### STAFF REPORT KETCHUM PLANNING AND ZONING COMMISSION SEPTEMBER 26, 2023 MEETING

**PROJECT:** Walnut Residence

FILE NUMBER: P23-052

**REQUEST:** Mountain Overlay Design Review & Lot Consolidation Preliminary Plat for a new 5,805

OVERALL SITE PLAN

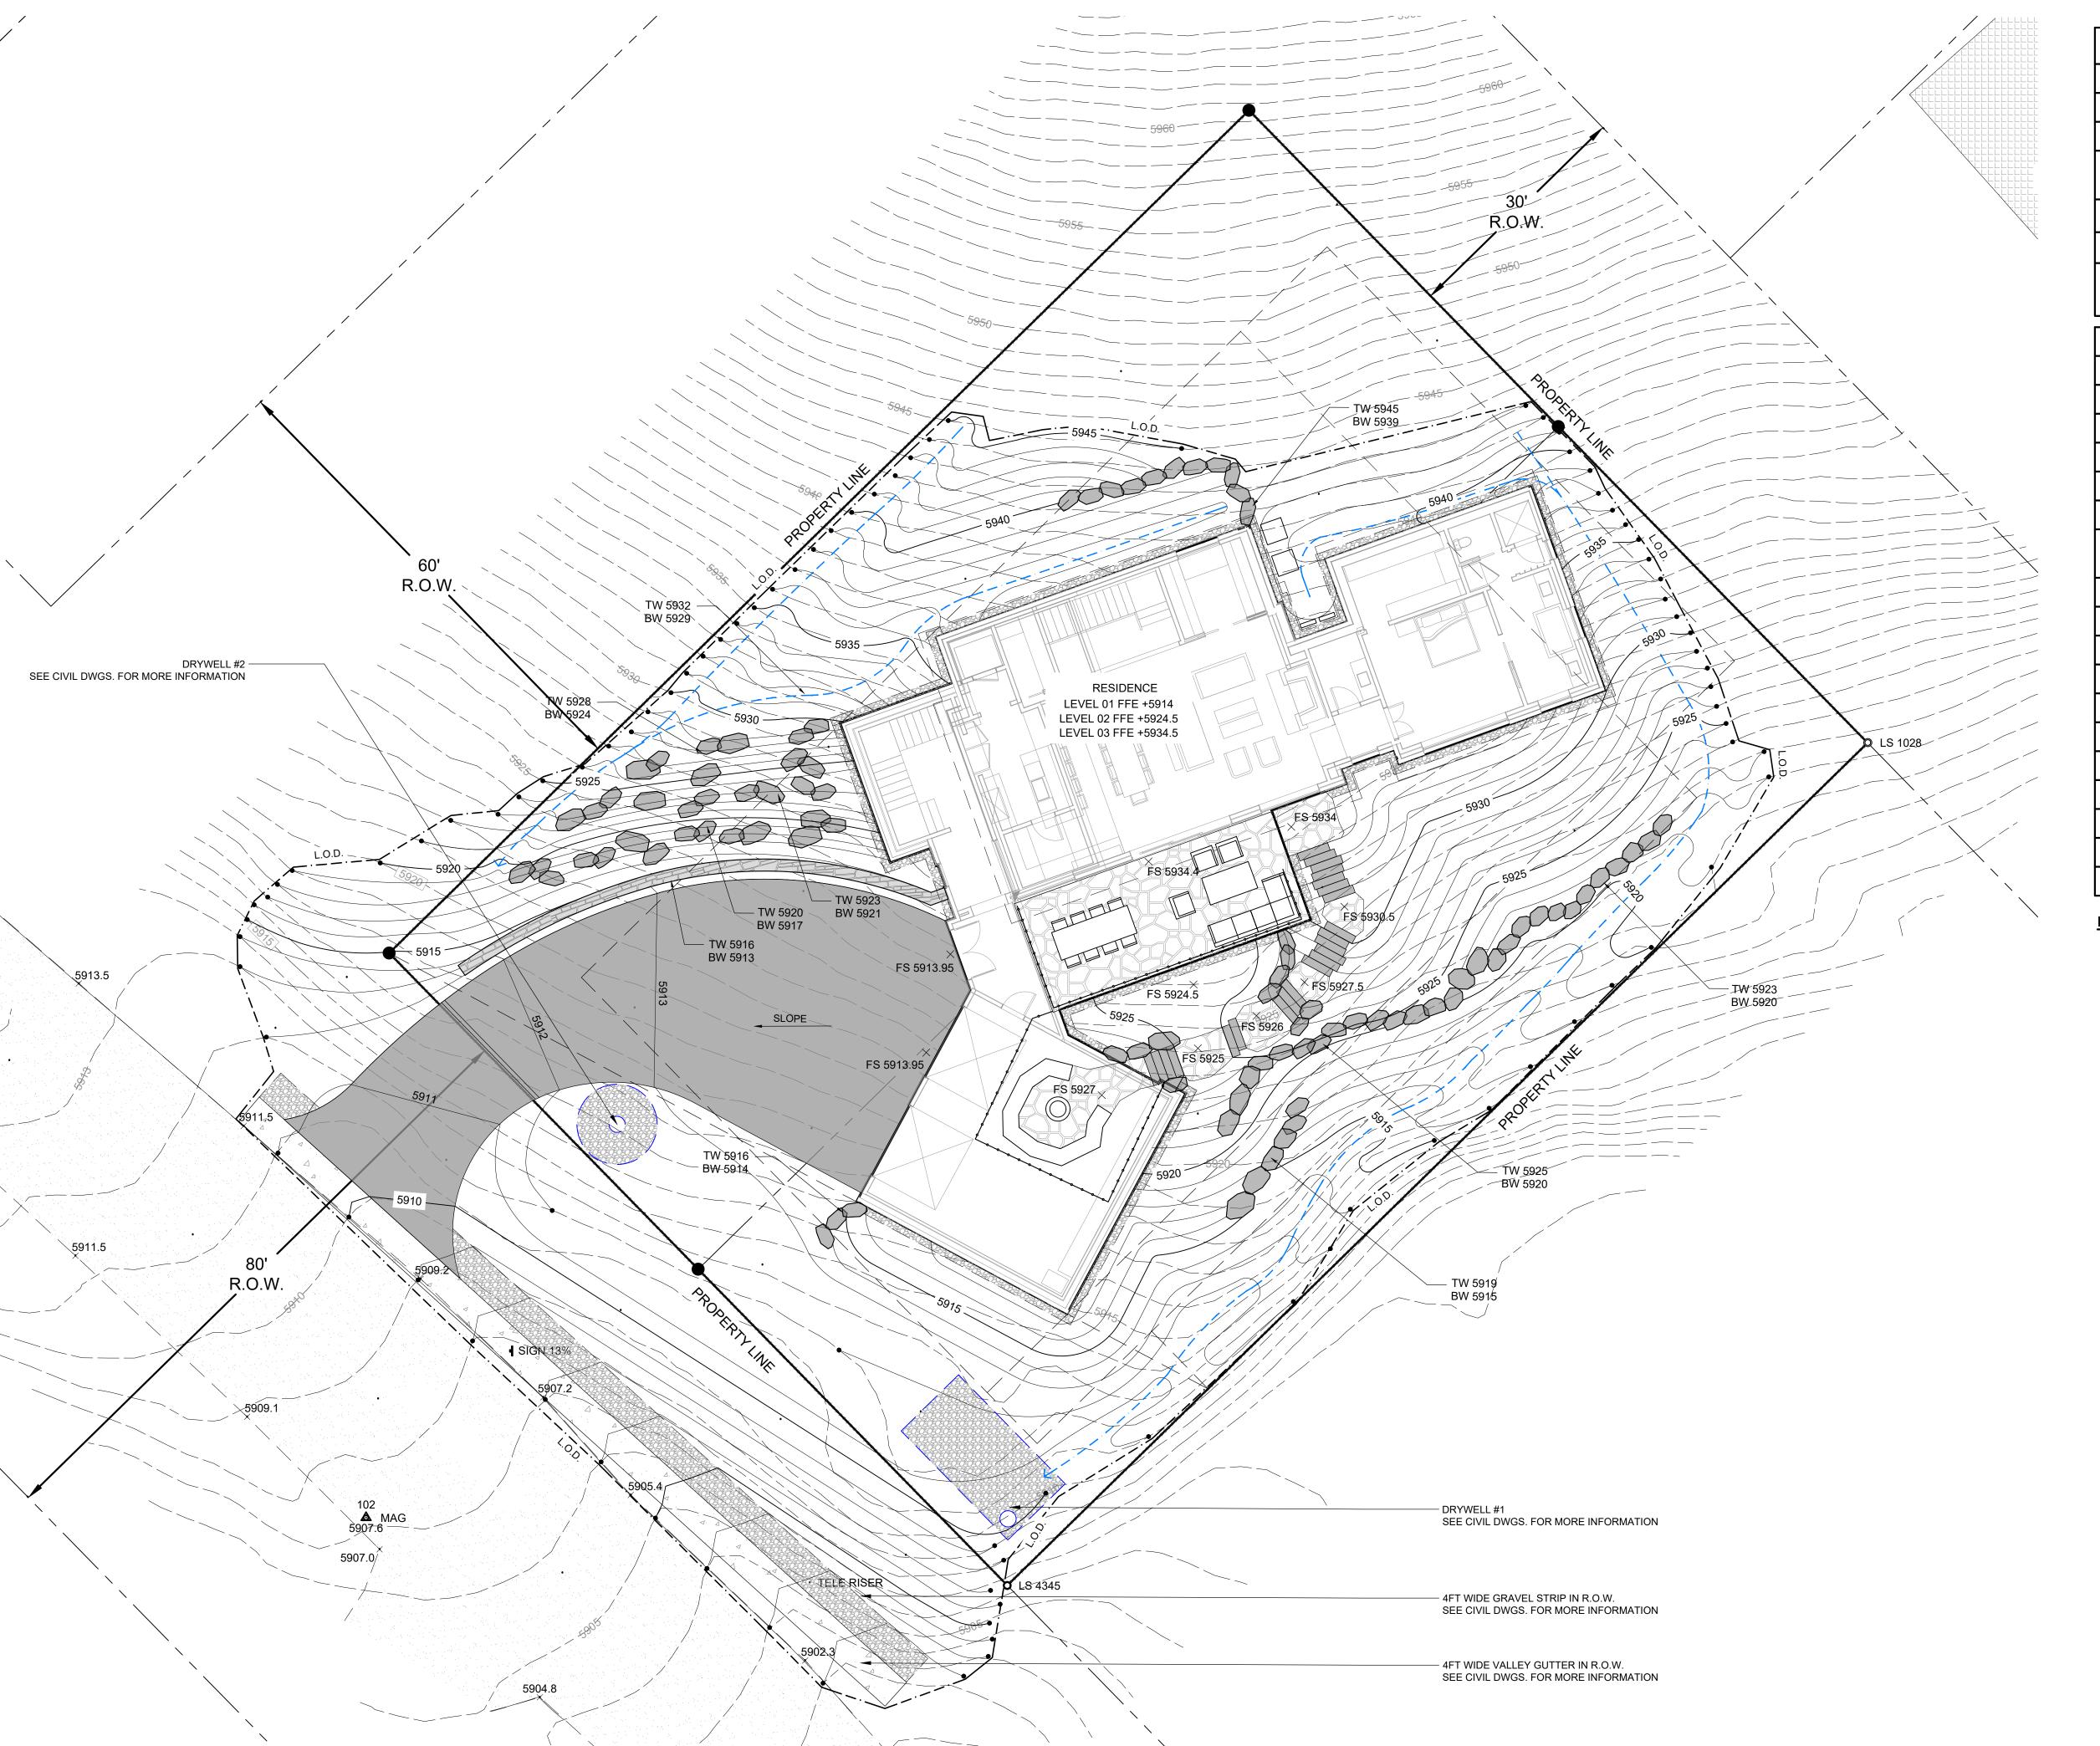
**Finding**: Sheets L1.0 show the proposed snow storage area to include 660 square feet, greater than the required 30% (1900 \* .30 = 570 square feet).

**Finding**: Sheet L-1.00 shows that no snow storage area has dimensions less than five feet.
